CENPD-283-NP-RAI, rev.1
(NRC TAC No. M86126)

**BWR ECCS Evaluation
Model: Boiling Water
Reactor ECCS
Evaluation Model:
Response to Request for
Additional Information
on Code Sensitivity for
SVEA-96 Fuel**

August 1995

ABB Combustion Engineering Nuclear Operations

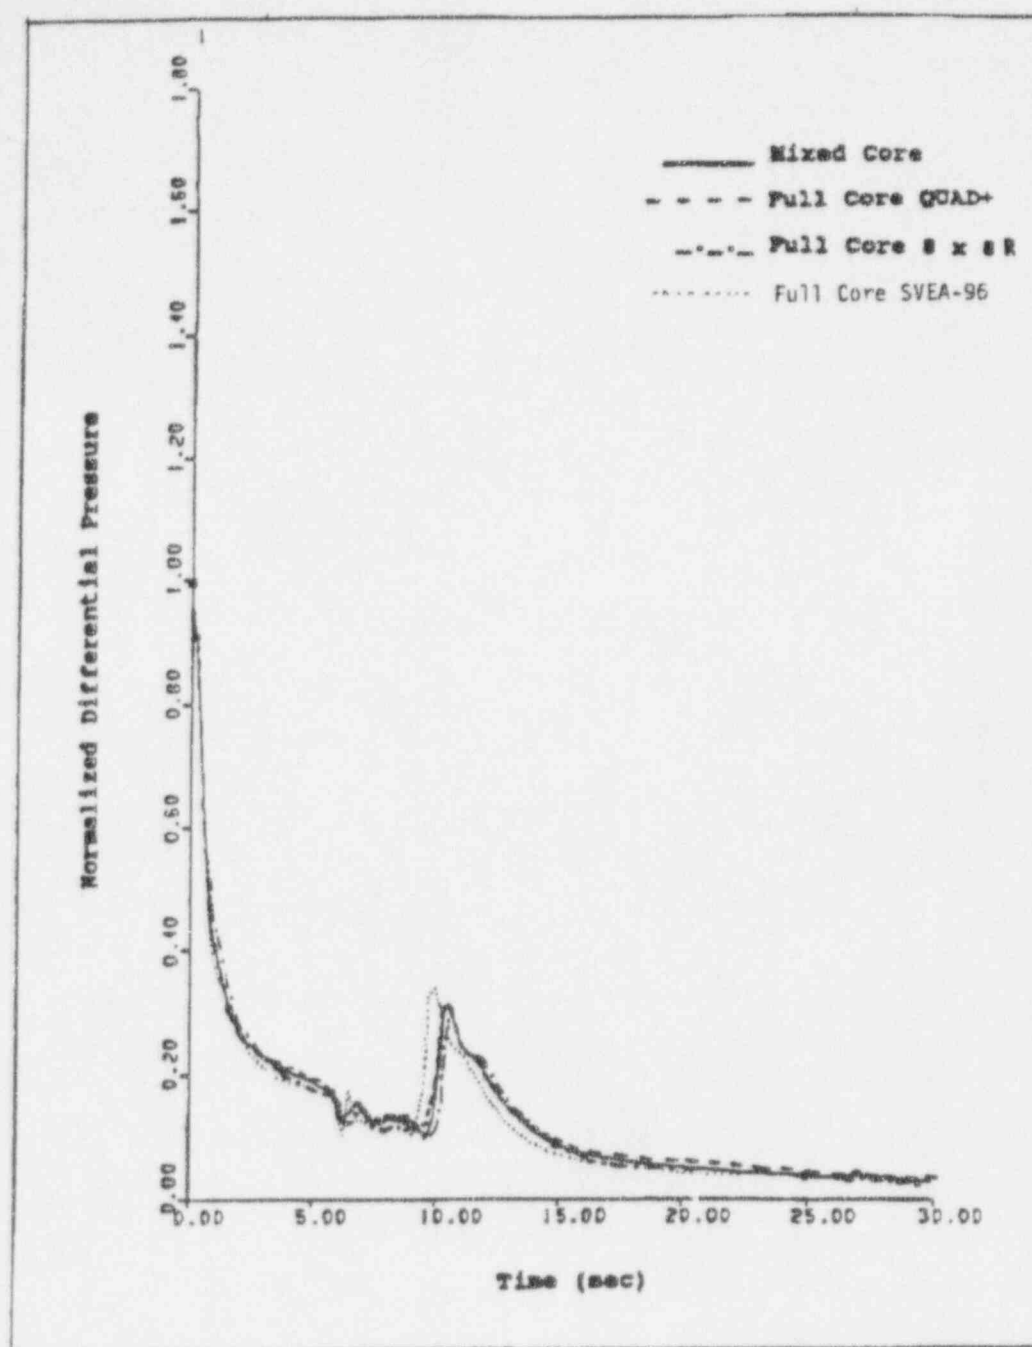
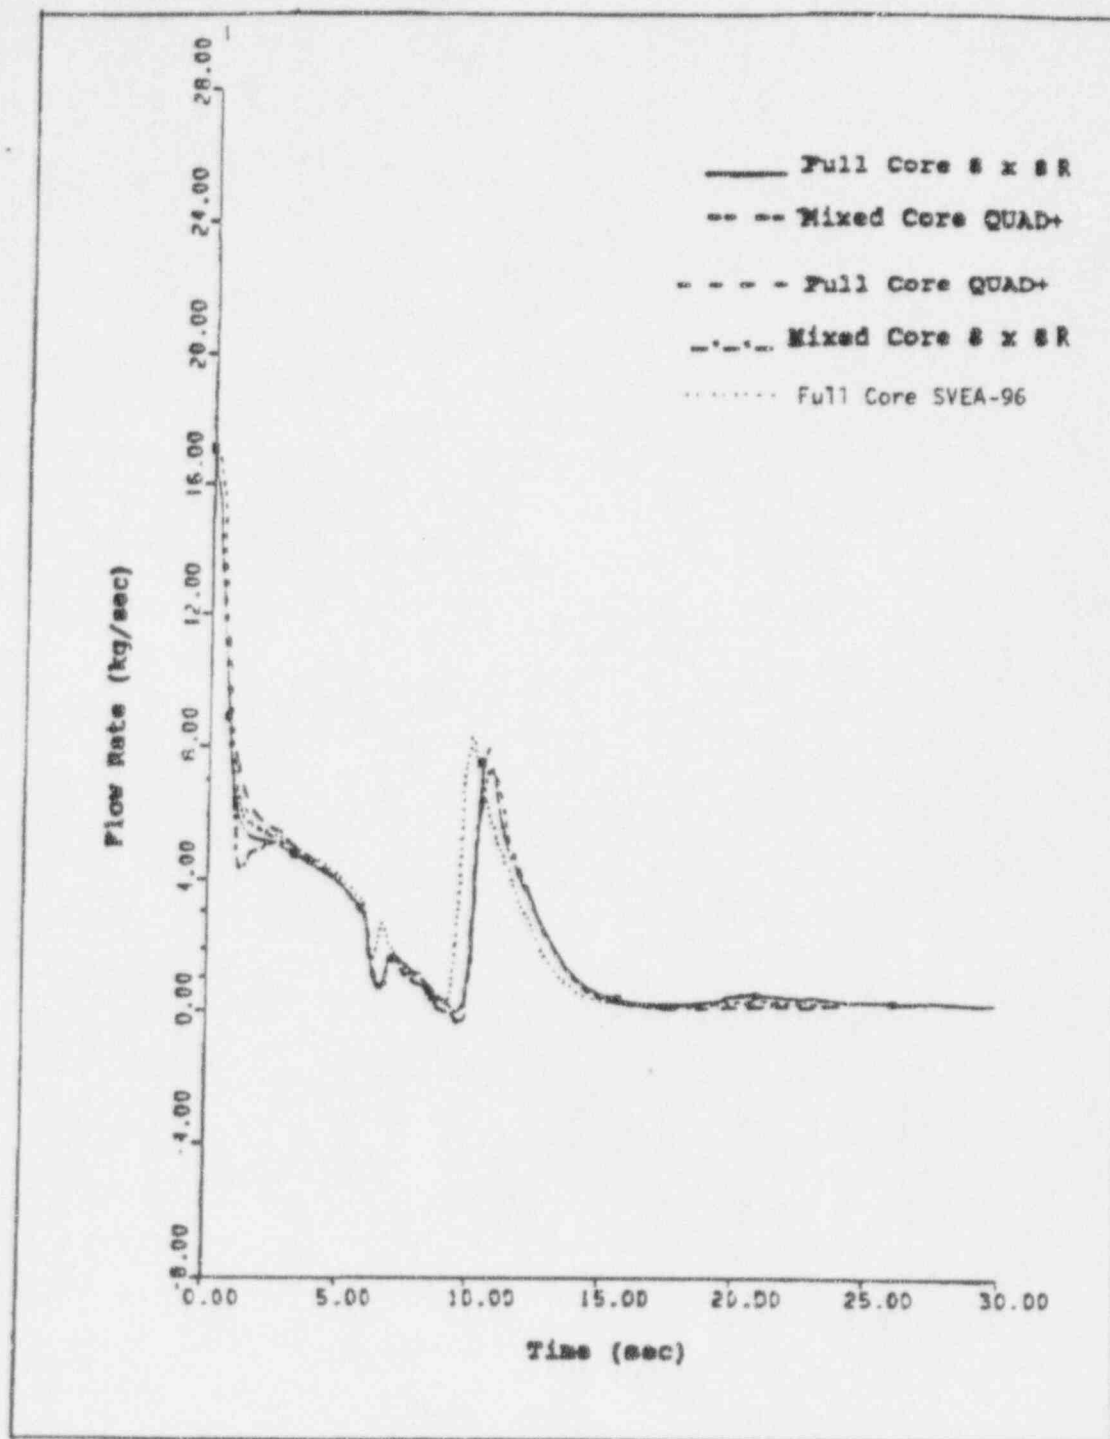
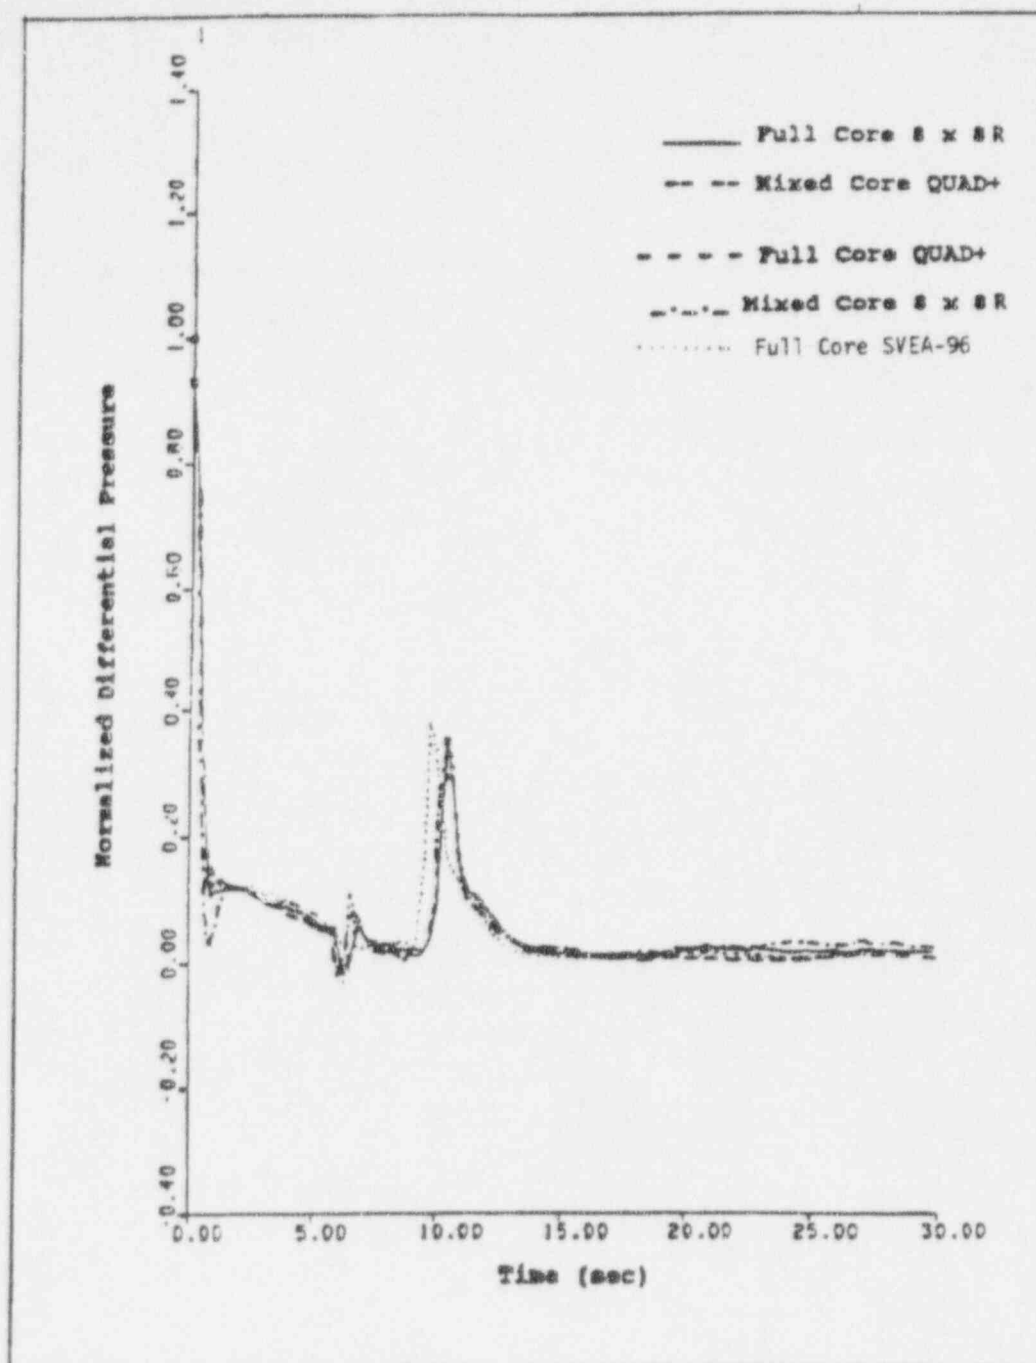
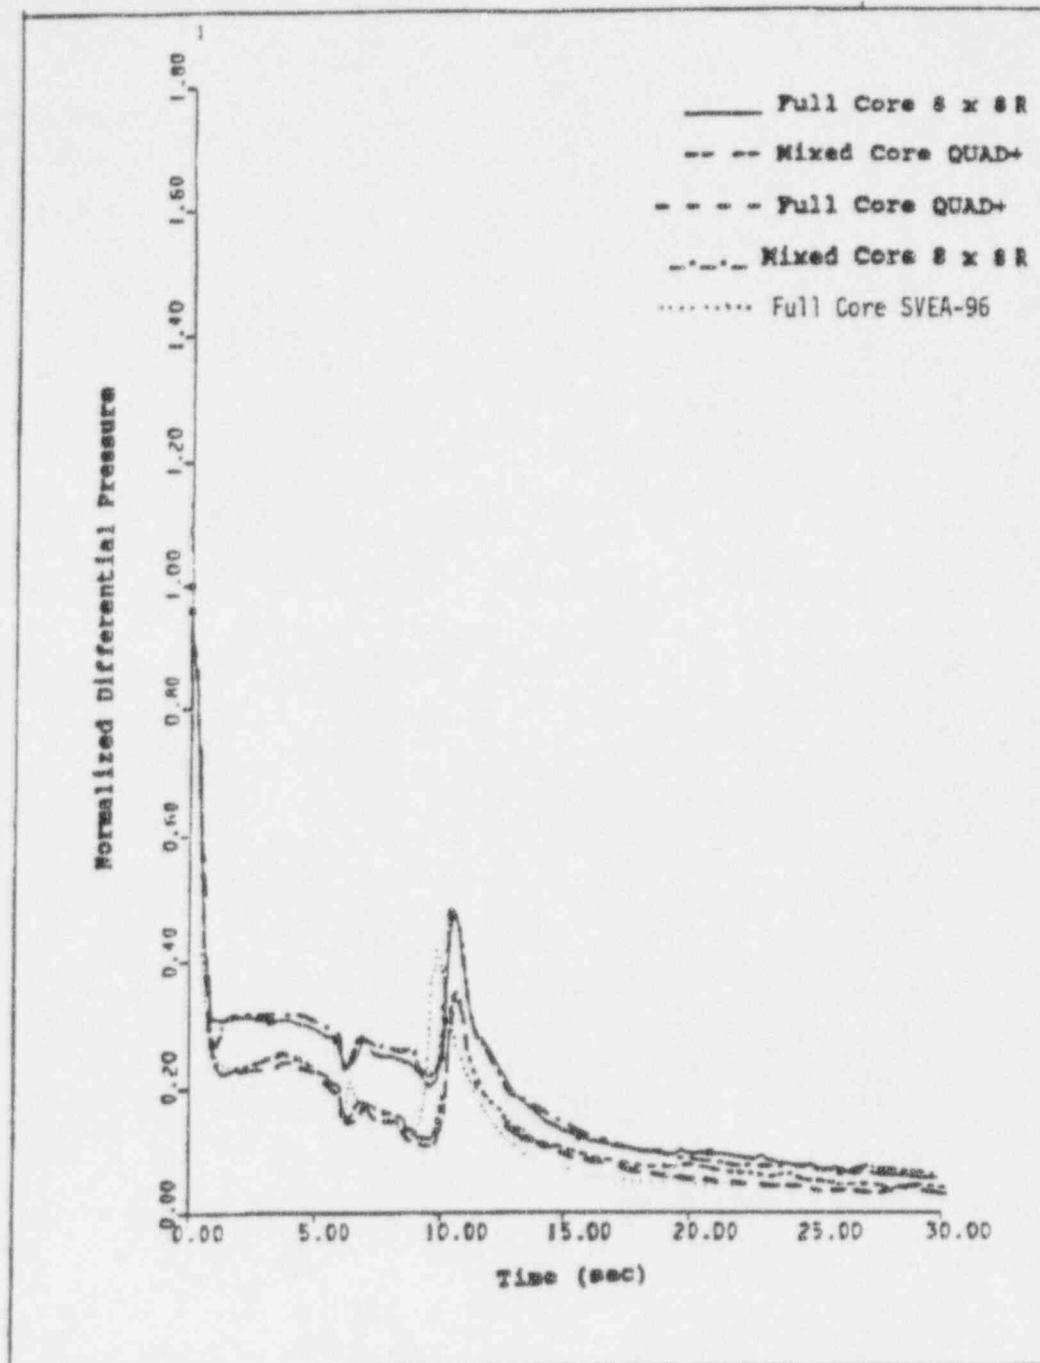
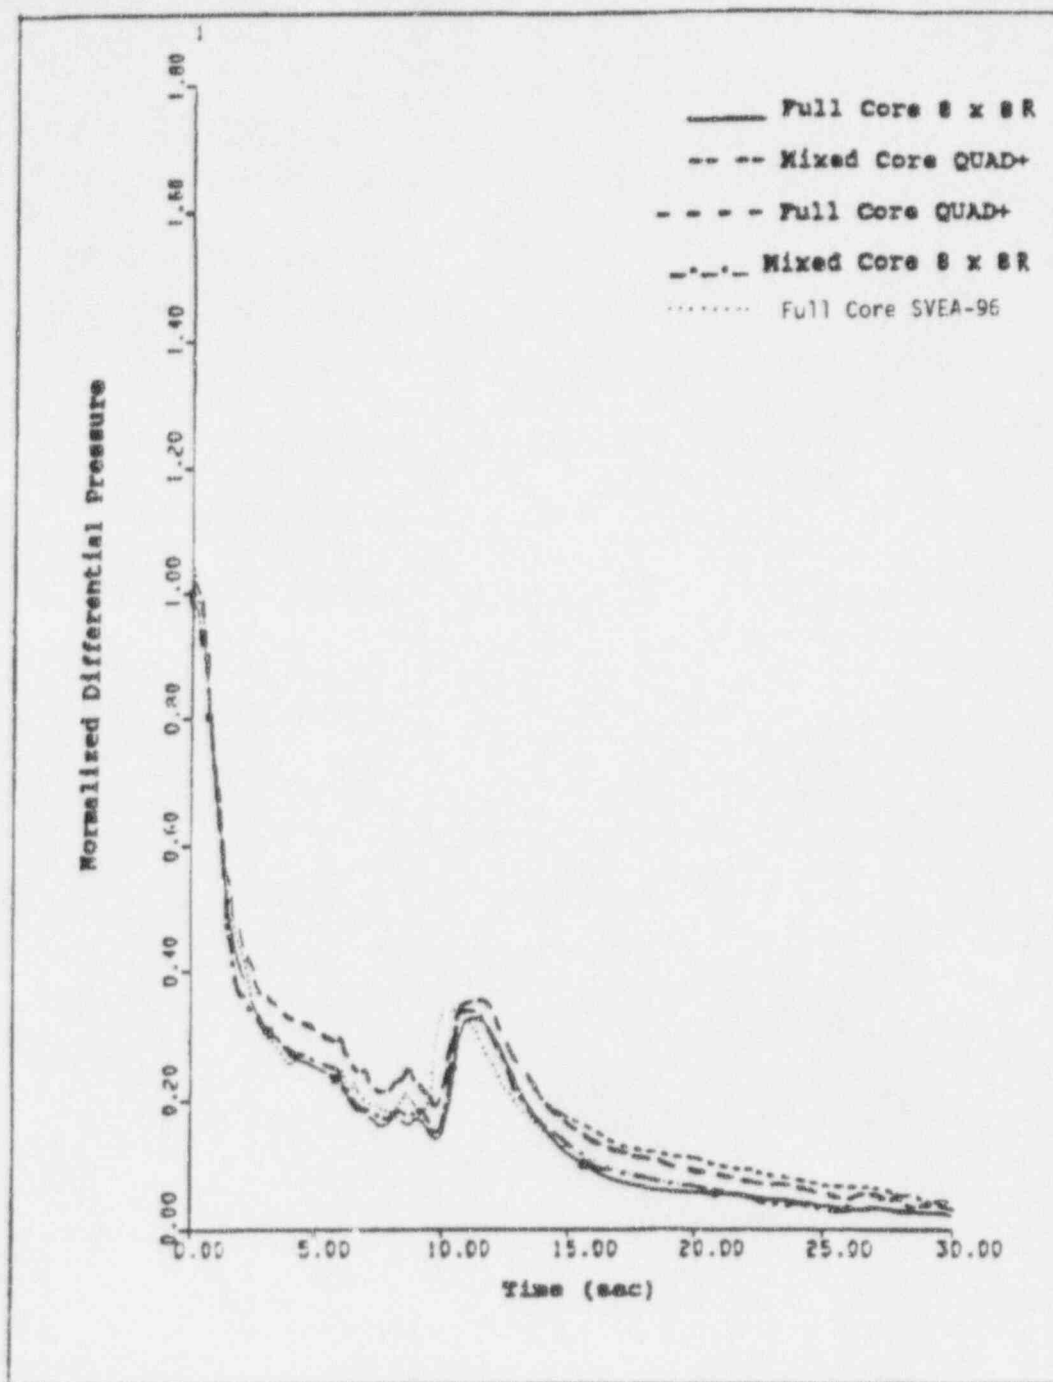
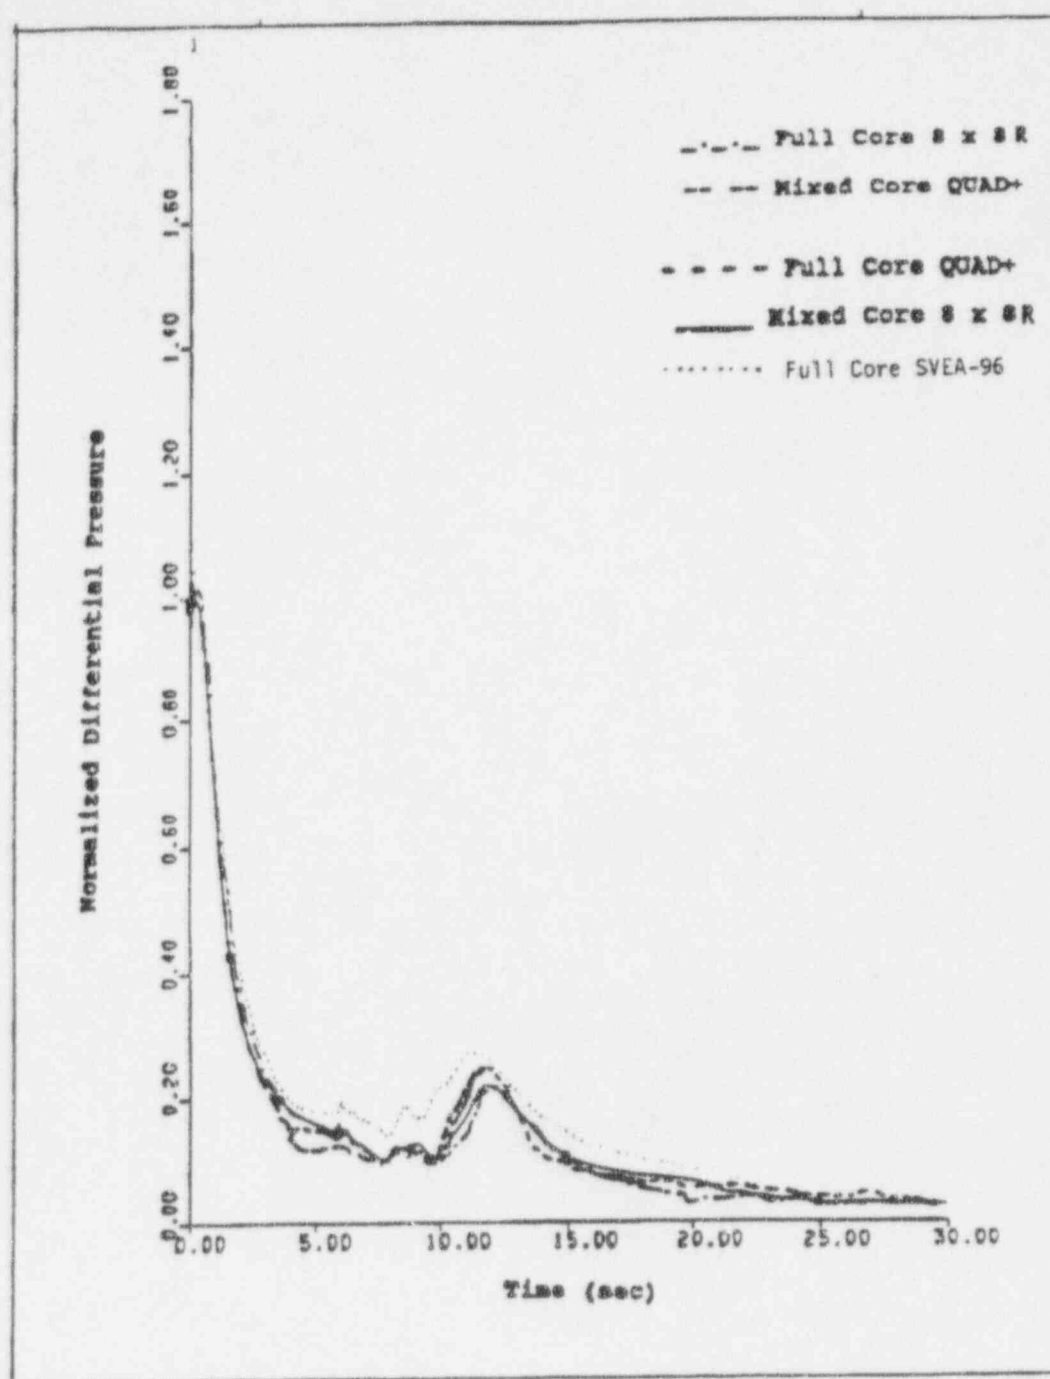
Mixed core effects should be investigated further to support ABB/CE's position regarding the transition cores by presenting mixed core analysis results with transition from QUAD+/SVEA64 fuel to SVEA-96 fuel. The watercross for each fuel design should be explicitly modeled in the nodalization. Provide plots from core void fraction, pressure, flow, and flow velocities.

To further demonstrate that the discussion presented and conclusions drawn in the response to Question 5 of RPB-90-94-P-A are valid in general, the results for a full core of SVEA-96 were compared to the previous system responses in Section 8 of Reference A1. Additional comparative results are shown in Figures A9-1 through A9-8 which correspond to Figures 5-1 through 5-8 on pages 18 through 25 of the Addendum to RPB 90-94-P-A. The core

compositions in the four cases presented in Figures A9-1 through A9-8 are:

<u>Core Description</u>	<u>8x8R</u>	<u>QUAD+</u>	<u>SVEA-96</u>
Full Core 8x8R	764	-	-
Mixed Core	260	504	-
Full Core QUAD+	-	764	-
Fuel Core SVEA-96	-	-	764

For the Mixed Core case, as applicable, both QUAD+ and 8x8R channel results are shown in the figure. There are insignificant differences between the system responses of the four cores presented.

As discussed in Response 5 of RPB-90-94-P-A small differences in the responses are attributed to differences in fuel component designs. As noted in Response A1 of this document, the SVEA-96 core used as an example was not specifically designed to be hydraulically comparable with the previous example cores (i.e., QUAD+ and 8x8). Hence, in some instances in Figures A9-1 through A9-8, the SVEA-96 results deviated slightly more than those observed for the other cores configurations. However, the overall system responses are very similar.

The results presented here further substantiate the general conclusion that the core average system response is relatively independent of local differences in fuel assembly design.
